STAFF REPORT
COMMUNITY DEVELOPMENT DEPARTMENT

HEARING DATE: 3/9/2021
 TO: Mayor & City Council
 FROM: Joe Dodson, Associate Planner
 208-884-5533
 SUBJECT: H-2020-0120
 Chewie Subdivision
 LOCATION: The site is located at 2490 W. Franklin Road and the lot directly north, in the S ½ of Section 11, Township 3N., Range 1W.

Preliminary Plat consisting of six (6) industrial lots on 43.87 acres of land in the I-L zoning district, by Kent Brown Planning.

A. Preliminary Plat (dated: 11/13/2020)

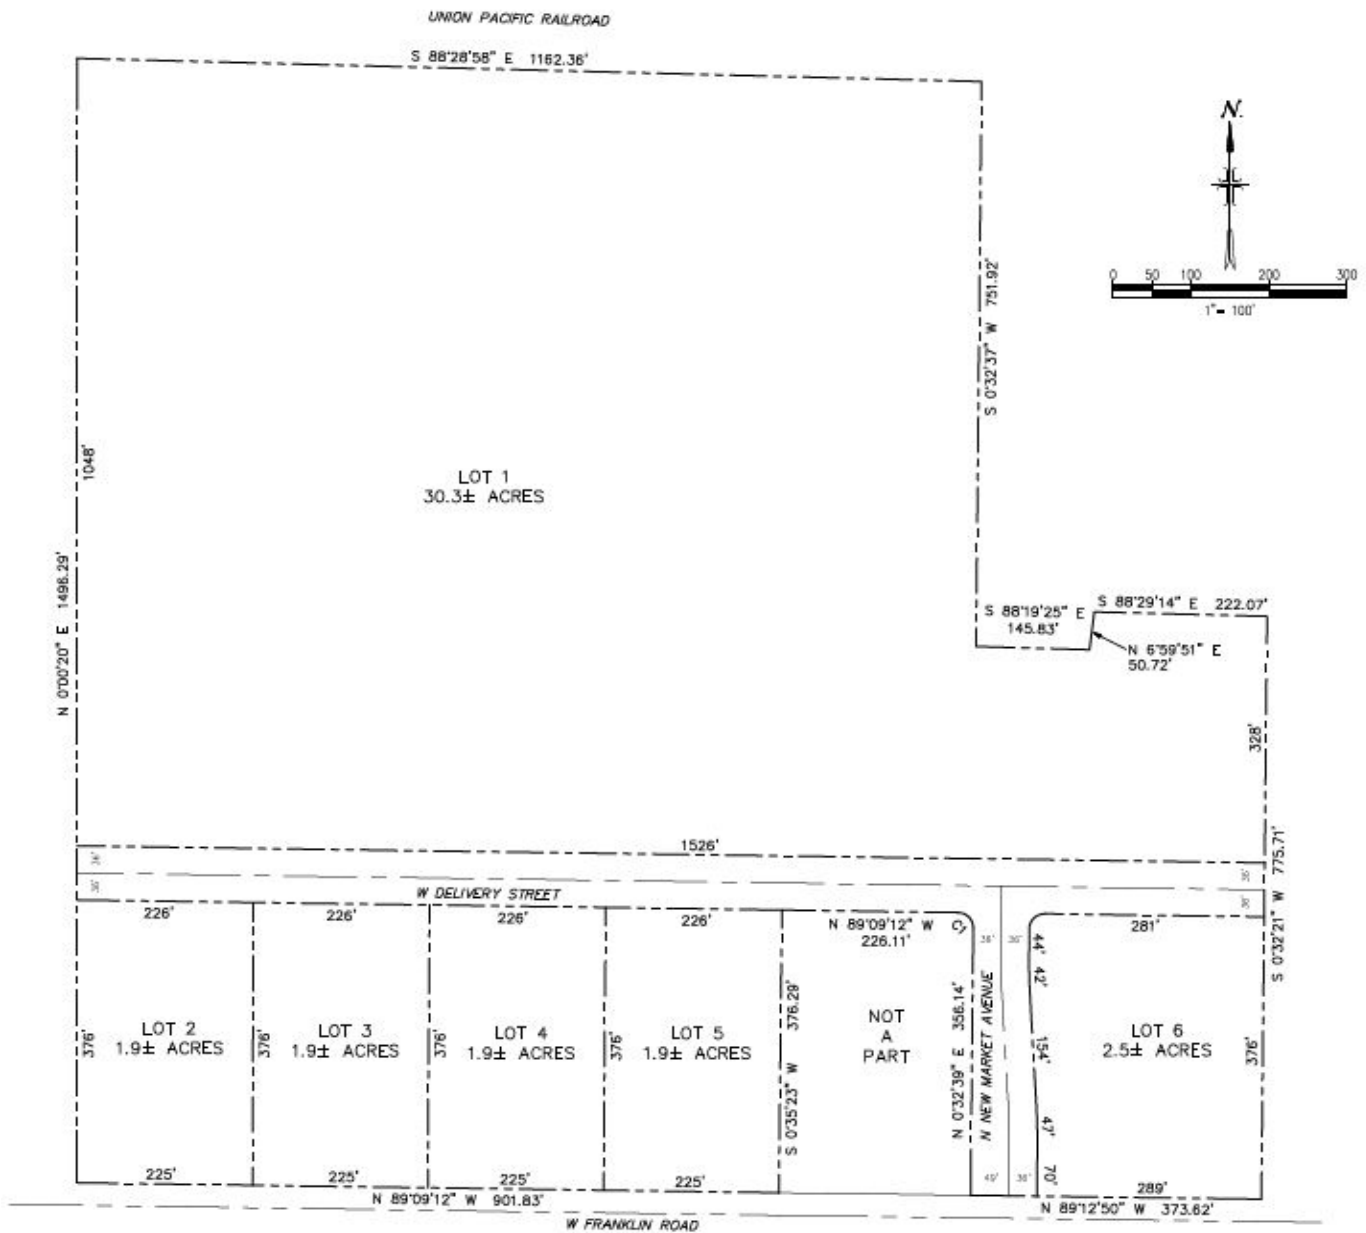
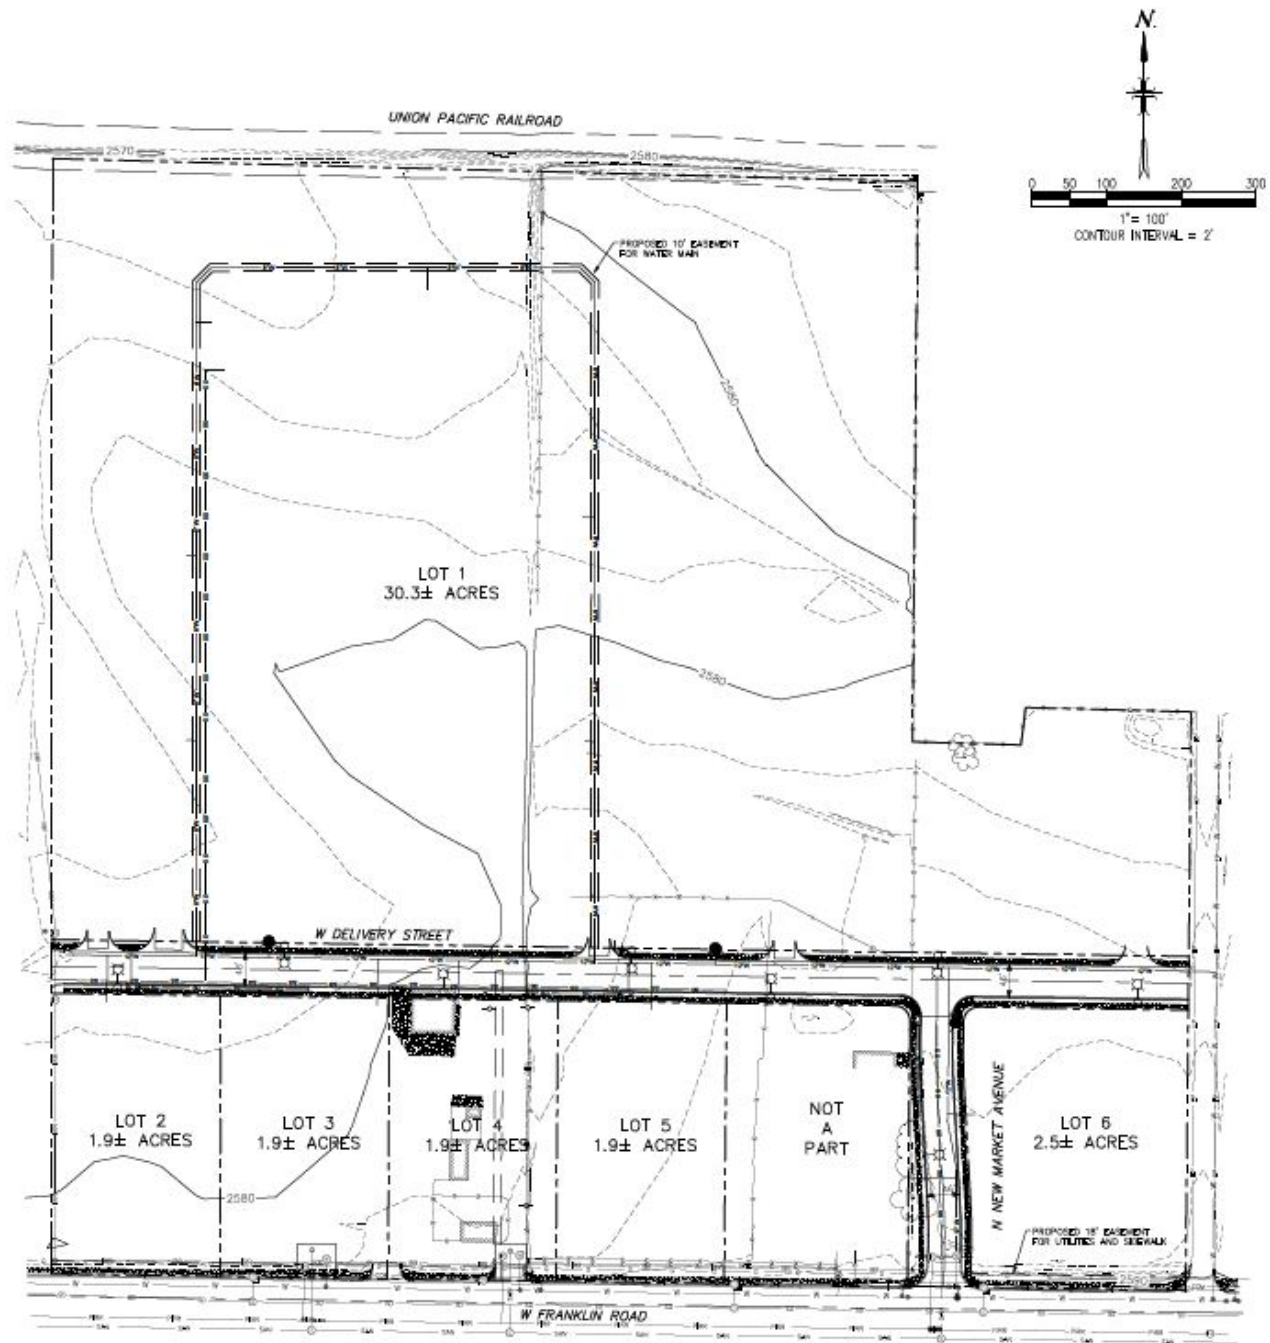
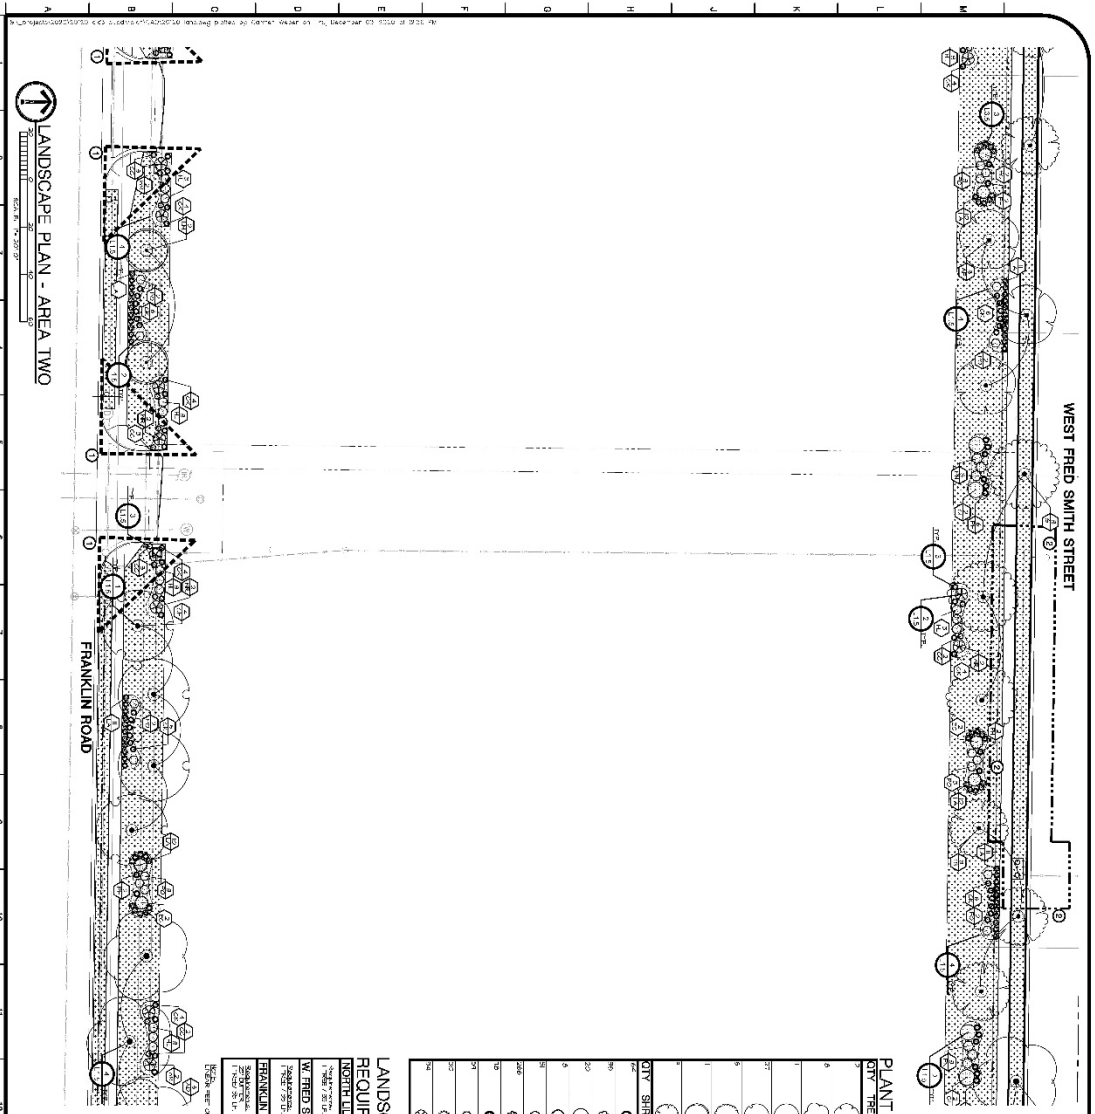
Other than the road extension and access points discussed within the TIS, the submitted plat and landscape plan show the existing accesses to Franklin to remain which does not align with code as they will have a lesser classified street (Fred Smith Street is a collector) to take access from. Therefore, these accesses should be closed with curb and gutter upon construction of the new

collector roadway. As noted, there is a lot that this preliminary plat surround and contains an existing home that is legal but nonconforming in the I-L zoning district; currently, this home also takes access from Franklin. Commensurate with Staff's previous comment, this access should be closed but because this parcel is not part of this application, Staff cannot require this access to be closed. However, this Applicant should provide a curb cut for this property along the extended W. Fred Smith Street so that when this "outparcel" does redevelop in the future, it will have access to the collector street instead of to Franklin, an arterial. The submitted plans do not show an access being provided to this parcel and this should be corrected prior to Final Plat submittal.

1. The preliminary plat included in Section VII.A, dated November 13, 2020, shall be revised as follows prior to Final Plat submittal:
 - a. Close the existing access points to Franklin Road shown on Lots 3 & 4, per UDC 11-3A-3.
 - b. Provide and visually show an access to the Morrow property (Parcel #S1211438440) from the new collector street, W. Fred Smith Street.
 - c. Revise the plat to show the collector street (W. Fred Smith Street) segment east of N. New Market Avenue as a private street commensurate with ACHD recommendations.
 - d. Depict the required landscape buffer easements on the plat where applicable (adjacent to Franklin Road, New Market Avenue, and W. Fred Smith Street).

- e. Revise the plat to show the required lot AND block for the proposed subdivision – submitted plat does not list any block numbers.
2. The landscape plan included in Section VII.B, dated October 16, 2020, shall be revised as follows prior to submittal of the Final Plat application:

CHEWIE SUBDIVISION
 FRANKLIN ROAD
 MERIDIAN, IDAHO
 LANDSCAPE PLAN - AREA TWO

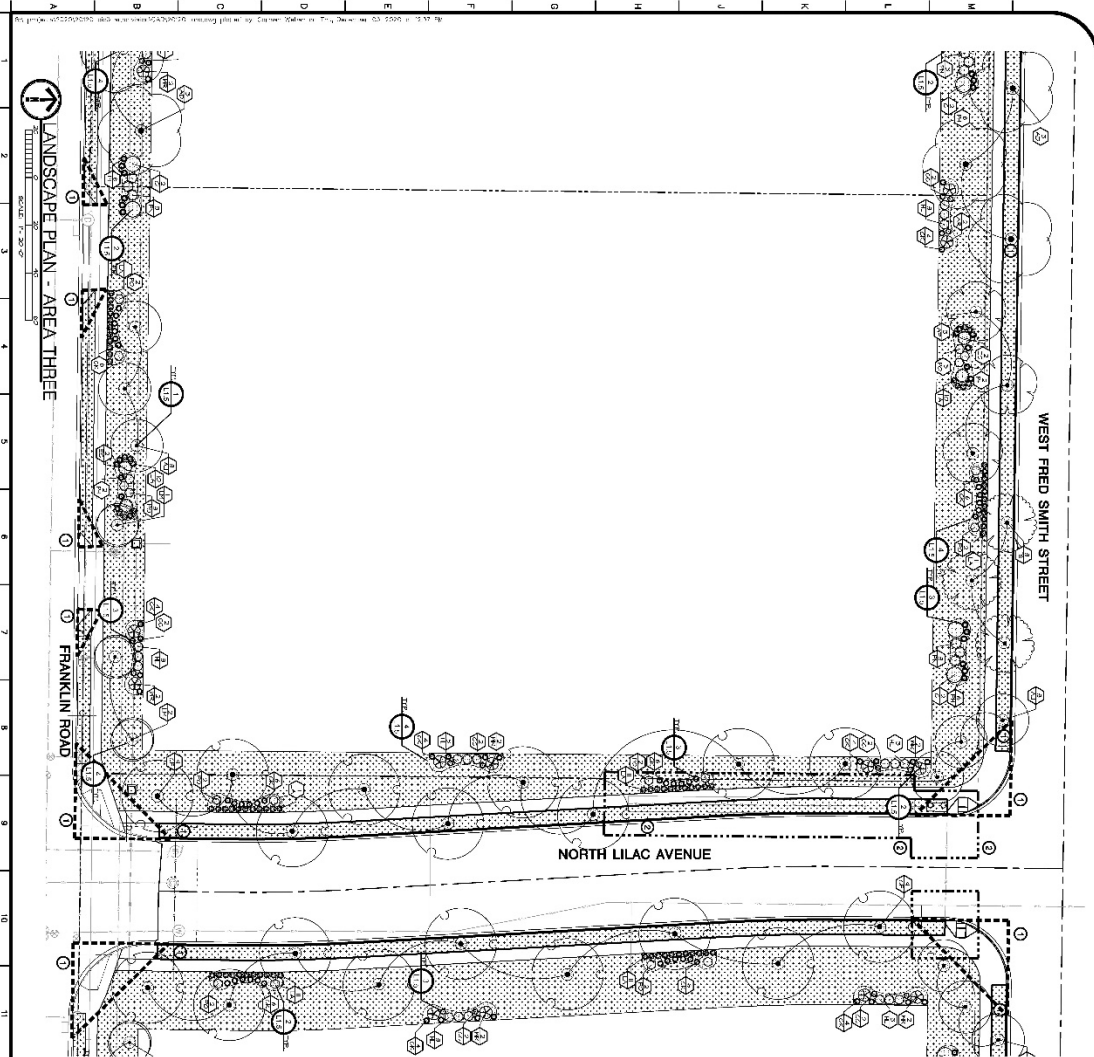
A 25-foot wide street buffer is required adjacent to W. Franklin Road, an arterial roadway, landscaped per the standards listed in [UDC 11-3B-7C](#). A 25-foot wide buffer is depicted on the landscape plans starting at the edge of right-of-way and includes the existing detached sidewalk along Franklin, meeting the UDC requirements. There is also a required 20-foot wide landscape buffer on both sides adjacent to W. Fred Smith Street, the proposed industrial collector roadway. The submitted landscape plan shows a compliant buffer on the south side but the plans do not show the north side buffer because it is being constructed with the DID3 site improvements. Commercial and Industrial areas do not require the landscape buffers to be within common lots and instead can be within easements. The submitted plat **does not** appear to show the required easements for these buffers but does show the correct amount of landscaping per the UDC standards. Staff is recommending a condition of approval to show the required buffers within easements prior to Final Plat submittal—the plat should show the easements on both sides of the collector roadway regardless of when it is being constructed.

- a. Show the required 20-foot landscape buffer on the north side of the collector street (W. Fred Smith Street) regardless of if it will be constructed with a different application.
